Enclosure 7 to TN E-30551

**Changed Pages for the Safety Analysis Report for the Model  
MFC-1 Package (non-proprietary version)**

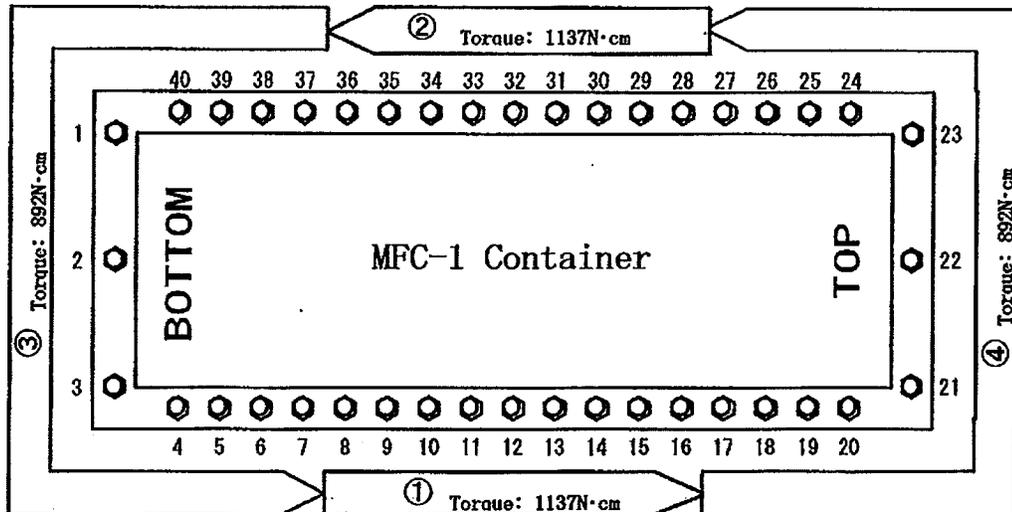
- 1) Tighten quarter-turn bolts until specified position (90 deg. clockwise) using open ended spanner
    - 2) Tighten setscrew of quarter-turn bolts using hexagon socket screw torque wrench (1137N·cm and 892N·cm) in accordance with the following order; (ref. following figure)

- a) Tighten the first nine (No.8 to 16) bolts with torque of 1137N-cm
      - b) Tighten the second nine (No.28 to 36) bolts with torque of 1137N-cm

- c) Tighten the third eleven (No.37 to 40, 1 to 7) bolts with torque of 892N-cm
      - d) Tighten the third eleven (No.17 to 27) bolts with torque of 892N-cm
